Identification Serial Number

UNLESS OTHERWISE SPECIFIED DIMENSIONS ARE IN INCHES						LIGO CALIFORNIA INSTITUTE OF TECHNOLOGY MASSACHUSETTS INSTITUTE OF TECHNOLOGY	
		TOLERANCES: FRACTIONAL ± 1/32 THREE PLACE DECIMAL ± .005 TWO PLACE DECIMAL ± .01 ANGULAR ± 1 deg.		FINISHED SURFACE RMS 63 BREAK CORNERS and EDGES ANGULAR MACH ± BEND ±-- REMOVE ALL BURRS				TITLE End Plate	
XXX	XXX	MATERIAL: Alum 6061 T-6	HEAT TREAT: /	FINISH: /	B	FOR FABRICATION	00	PRE-RELEASE	kenm 6-8-99
DWG. NO.	DESCRIPTION	USED IN: XXX	NEXT ASS'Y: XXX	REV	DESCRIPTION	DCN NUMBER	-	APPR'D	CHECK
6	REFERENCE DRAWINGS	5		4	ISSUE DESCRIPTION			2	DATE
								SCALE	
								SIZE	
								C D980320-B	
								D980320-B	
								SHEET

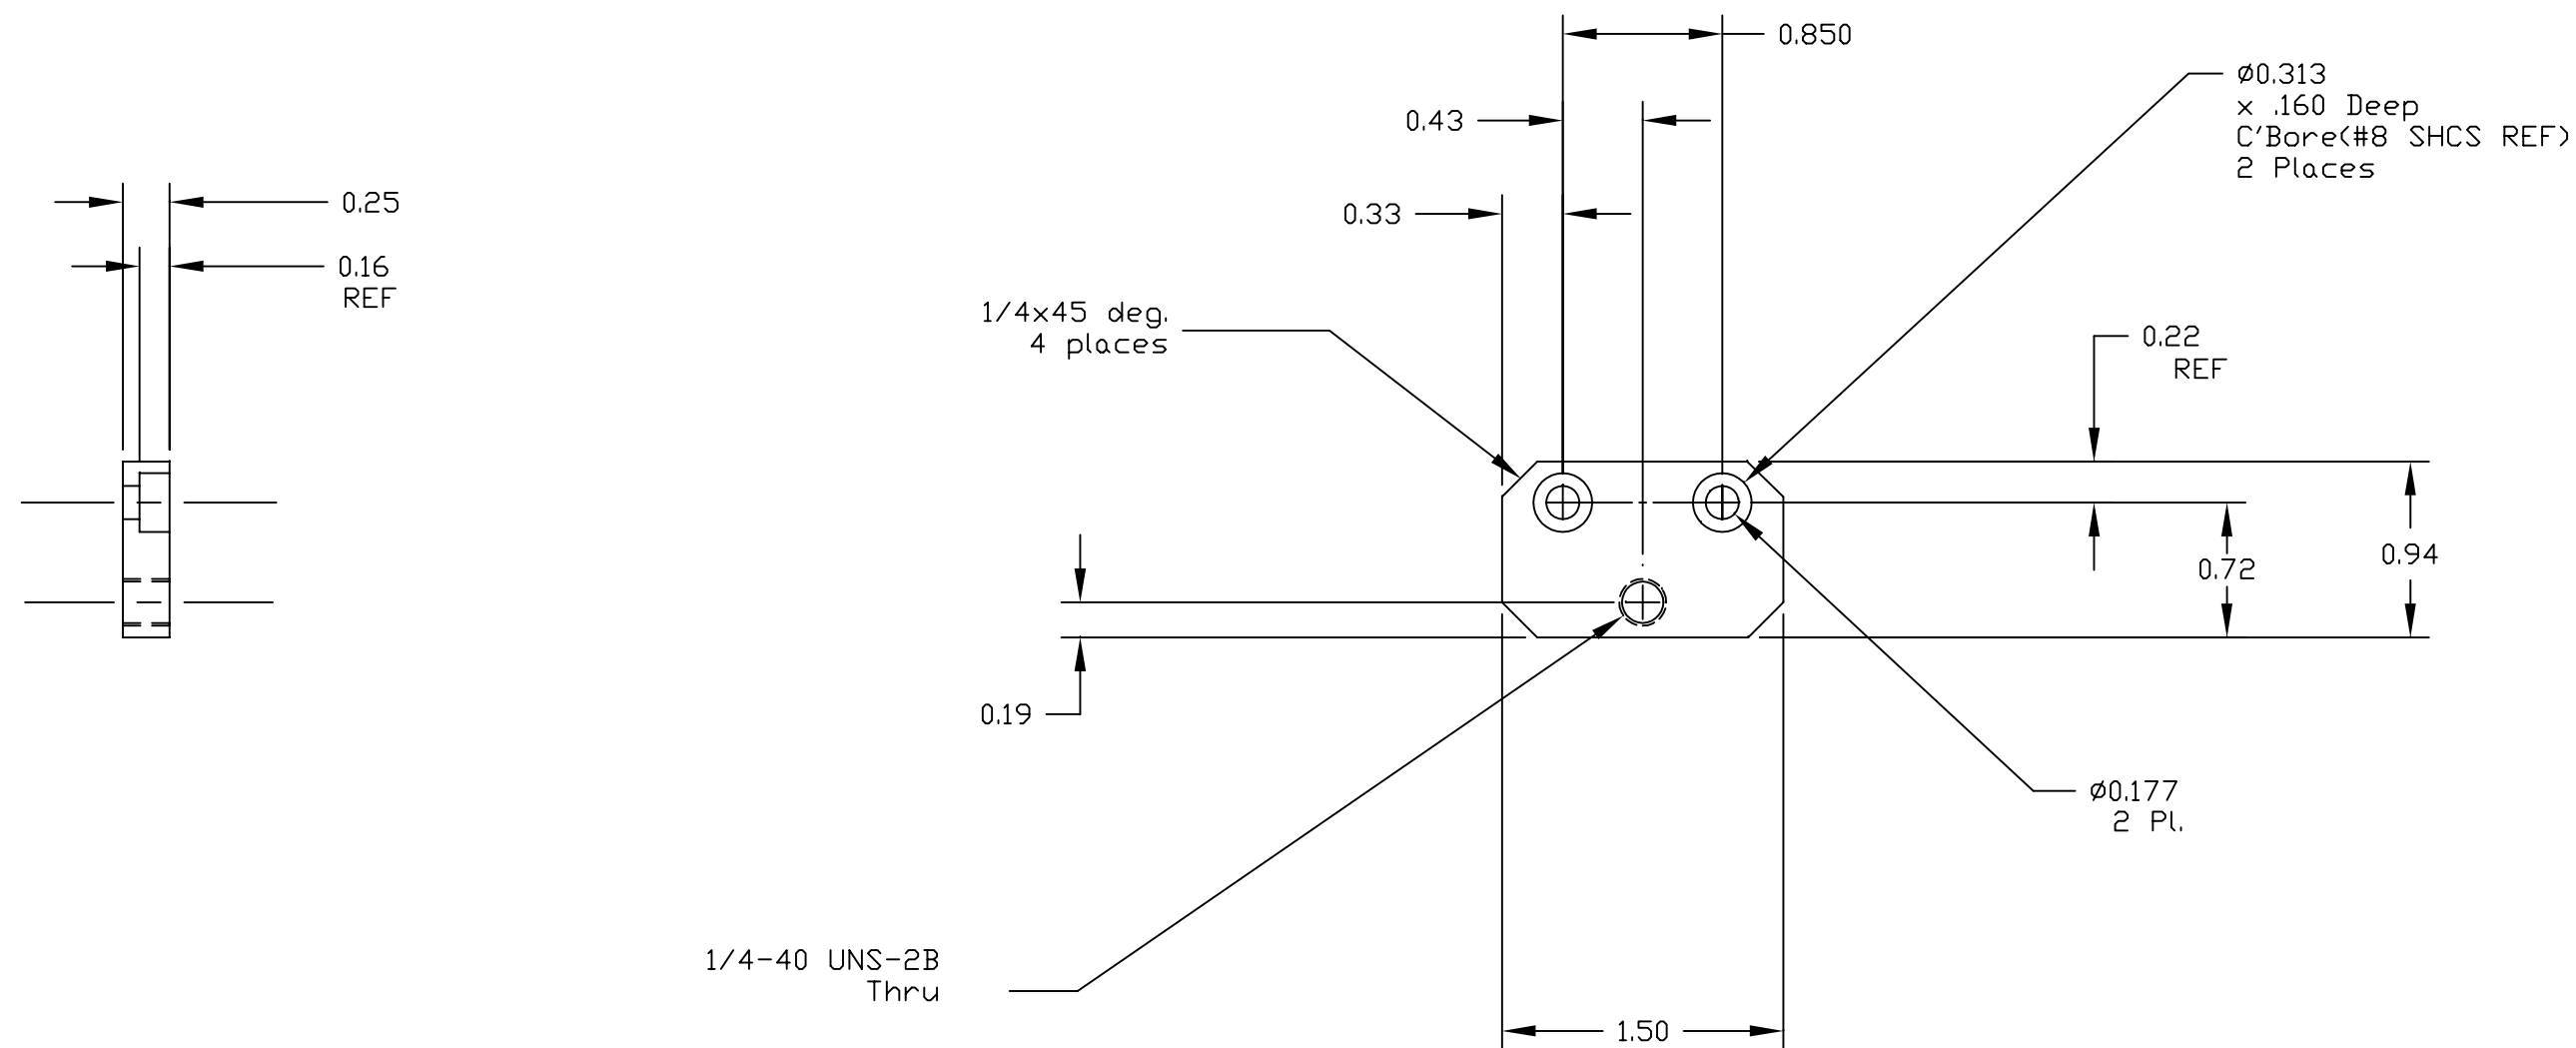
~~Liquid contaminants/Machining Lubricants~~
 Liquids containing hydrocarbons or other contaminants, other than the machining fluids specified herein, shall not be allowed to come into contact with suspension material at any time. All machining fluids shall be water soluble and free of sulfur, chlorine and silicone; such as Cincinnati Milacron's Cimtech 410 (stainless steel).
